Subject: AP1000 Response to Request for Additional Information (SRP 3)

# AP1000 TECHNICAL REPORT REVIEW

RAI Response Number: RAI COL03.05.01.04-1

Figure OI-SRP3.3.2-SEB1-01 – Siding Impact on Shield Building

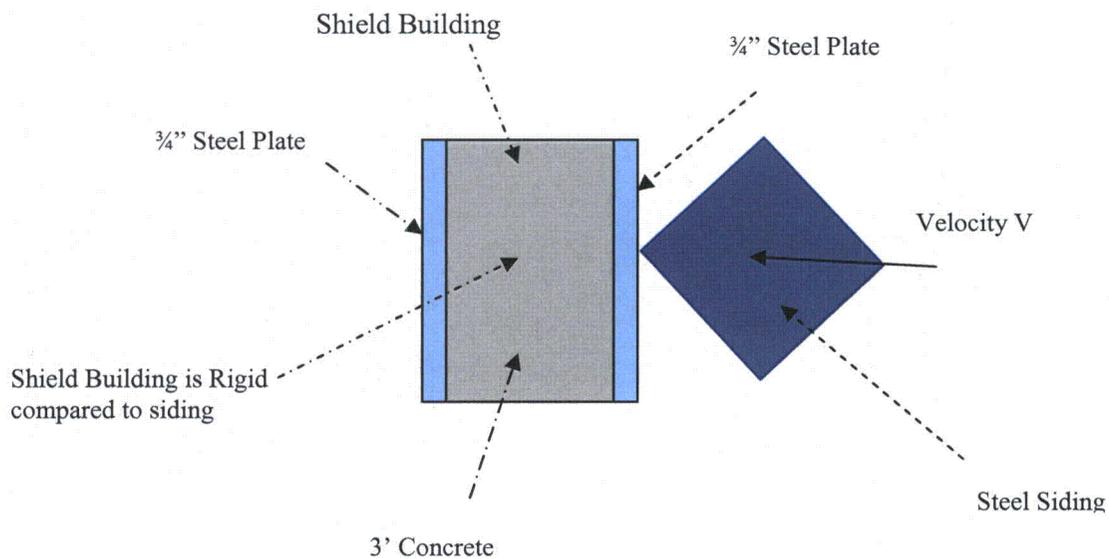
1. Provide quantitative evaluation the damage of a siding missile impact on steel plates and the potential for creating a non-stable crack. Siding is representative, corrugated type siding.
2. Include description of siding missile in DCD.

Conservatively, a three foot square portion of siding is assumed to impact the cylindrical portion of the shield building that would result in the maximum impact load. The three foot square was chosen since the siding is in three foot strips, and it is necessary to have the center of gravity of the siding in line with the point of impact so no rotation occurs. Rotation would lessen the effect of the impact. The siding impact on the shield building is shown in Figure OI-SRP3.3.2-SEB1-1.

Figure RAI-SRP3.7.1-SEB1-06-1: X-Direction Comparison

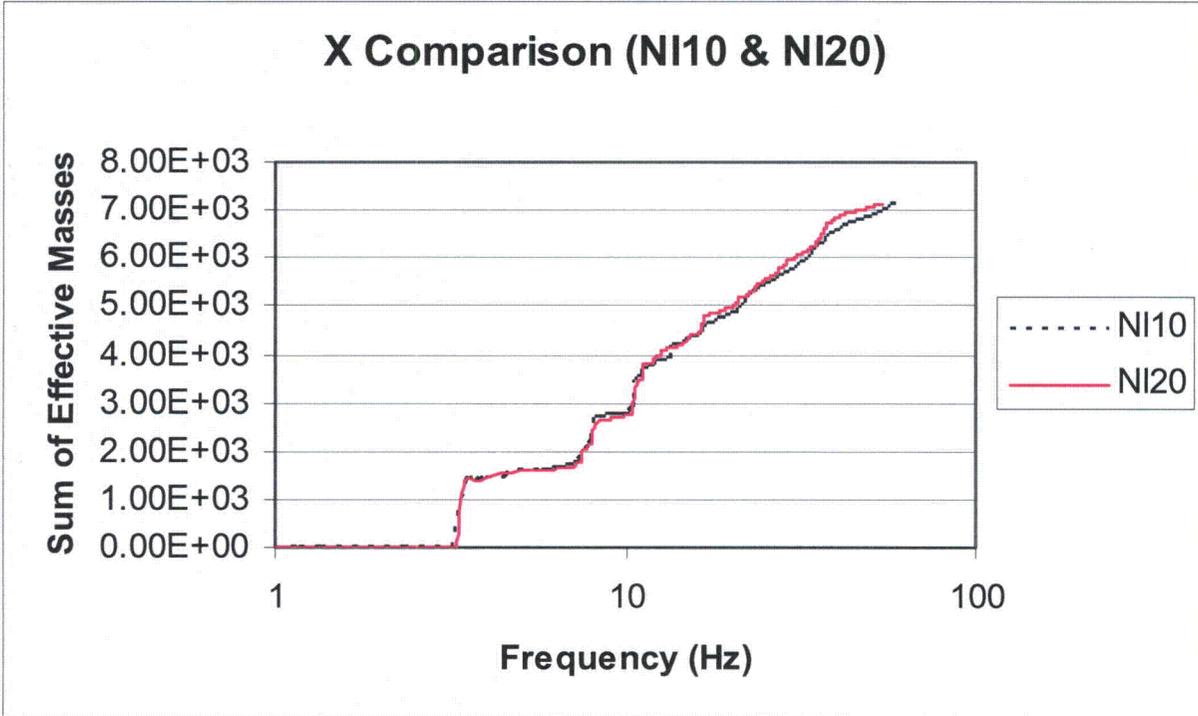
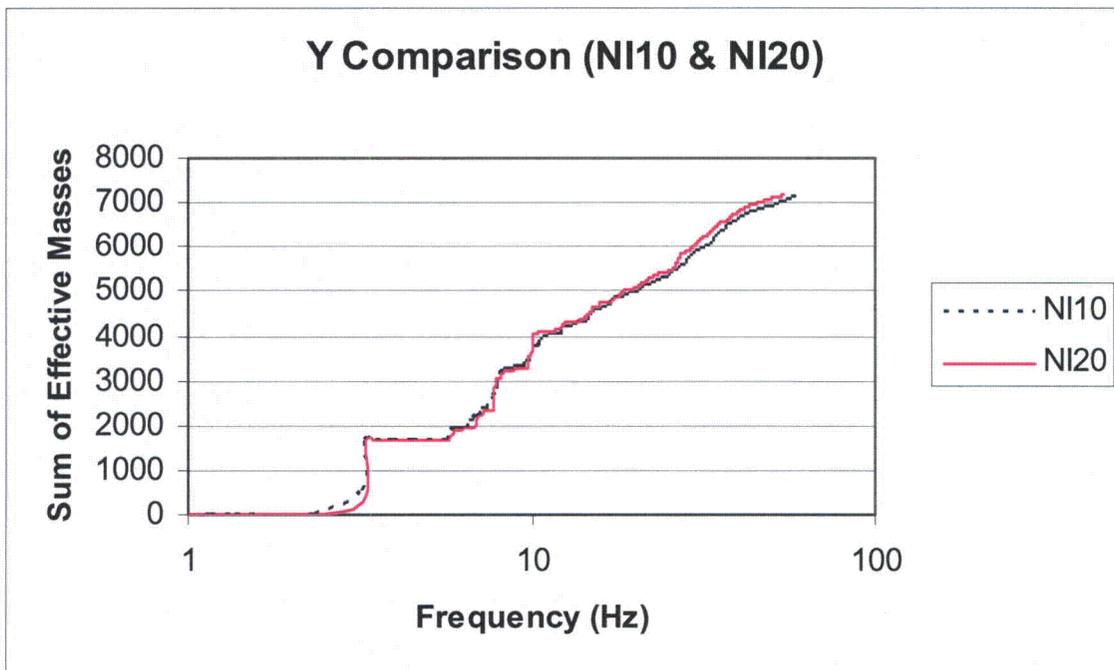
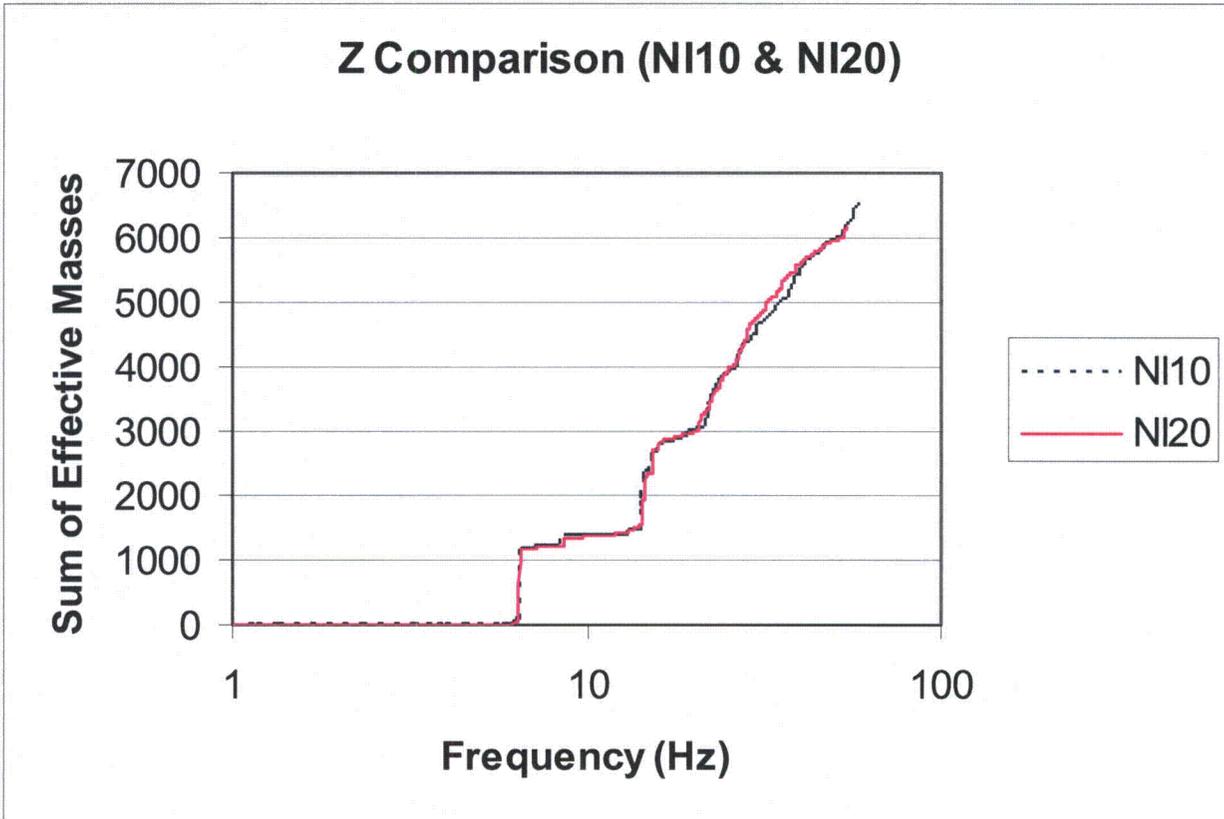
Westinghouse's calculation in TR-115 indicates 4 points per wavelength for 80 Hz. This is the bare minimum to represent a full cycle of sinusoidal displacement variation. The staff requests that Westinghouse include in Section 5.1 a comparison of frequencies and mode shapes between the NI10 and NI20 models, as an alternate way to demonstrate the adequacy of the NI20 model to accurately predict high frequency modes (up to 80 Hz).

- (a) In the 0-10 Hz range, there are 58 modes for NI20 and 69 modes for NI10. In the low frequency range, the correlation would be expected to be near 100%.
- (b) In the 10-40 Hz range, the difference in number of modes is very large: 658 for NI20; 1234 for NI10.
- (c) In the 40-55 Hz range, the difference in number of modes is relatively small: 484 for NI20; 545 for NI10.

Figures RAI-SRP3.7.1-SEB1-06-1 to RAI-SRP3.7.1-SEB1-06-3 show a summation of the of the effective mass versus frequency for the X, Y and Z directions. The effective masses associated with the NI20 and NI10 models compare closely over the frequency range of 1 to 80 Hz.

Figure RAI-SRP3.7.1-SEB1-06-04: HRHF Acceleration Response Spectra

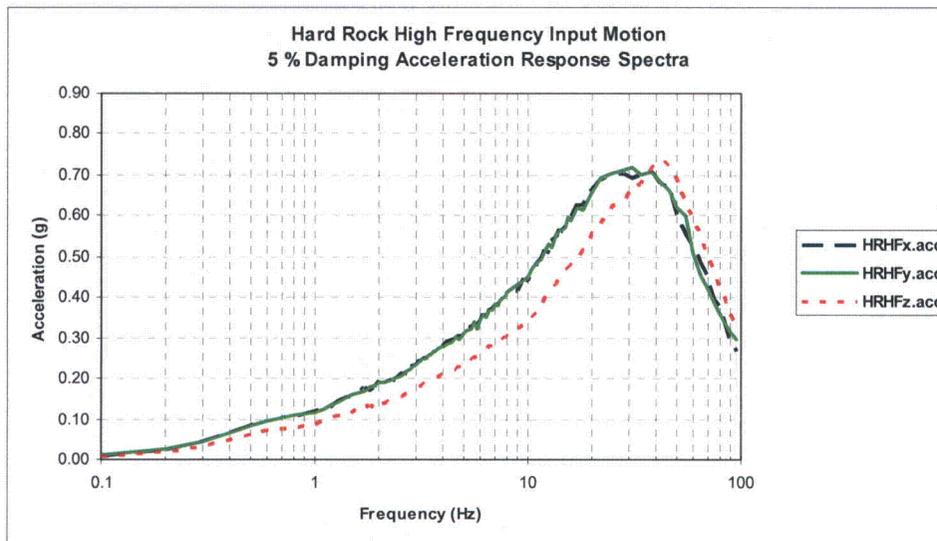
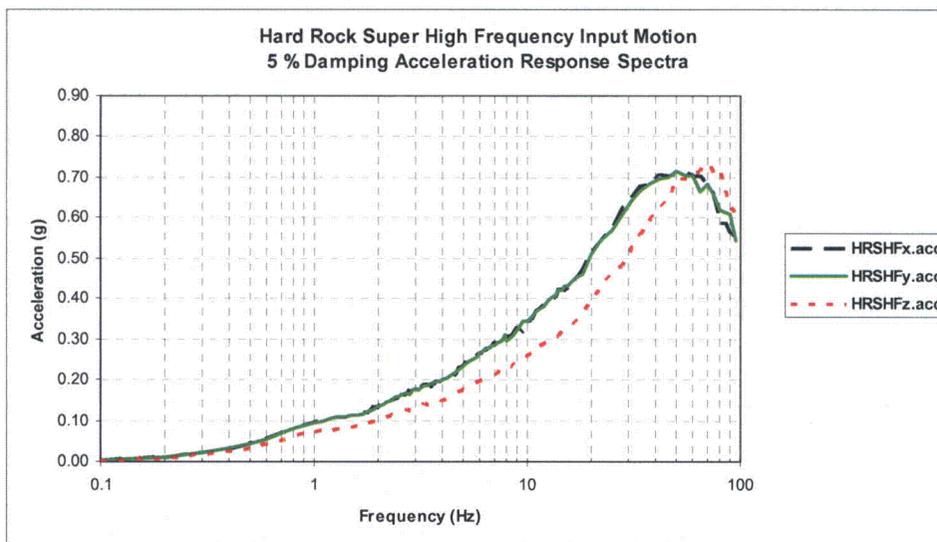
Please provide more detail.

The HRHF spectra peaks at about 25 Hz. In order to confirm the NI20 model’s adequacy for frequencies up to 50 Hz, a time history analysis was performed in ANSYS using the NI20 and NI10 models with the Westinghouse defined Hard Rock High Frequency (HRHF) input time history. The time step for the HRHF time history was changed from 0.005 to 0.003 seconds. This shifts the peak of the input time history to 50 Hz while maintaining the statistically

Figure OI-SRP3.7.2-SEB1-02-1 – Radwaste Monitor Tank

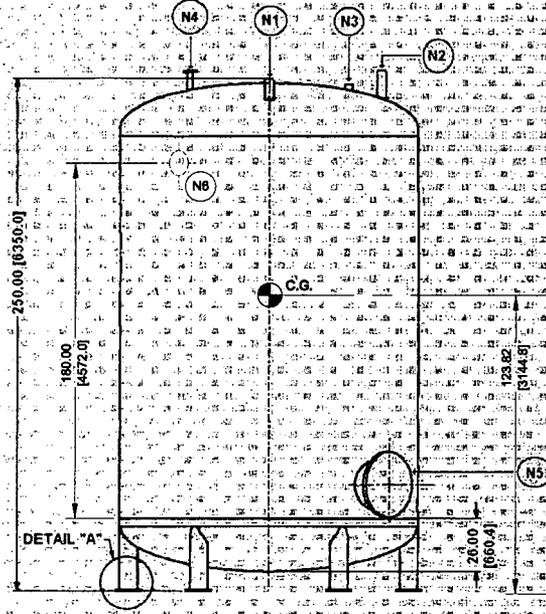
Evaluate the capability of a radwaste monitor tank to remain in place when exposed to tornado wind loads. The evaluation is to be based on the Class D level component analysis and building code structural evaluation.

The Radwaste monitor tank is shown in Figure OI-SRP3.7.2-SEB1-02-1. It is supported by six supports as shown in Figure OI-SRP3.7.2-SEB1-02-2.

The center of gravity is near the center of the tank as seen in Figure OI-SRP3.7.2-SEB1-02-1. Therefore, the equivalent static load associated with the tornado will act very close to the equivalent static load associated with the seismic load. Therefore, it is only necessary to compare the load acting on the tank due to a tornado and seismic events. If the load from the
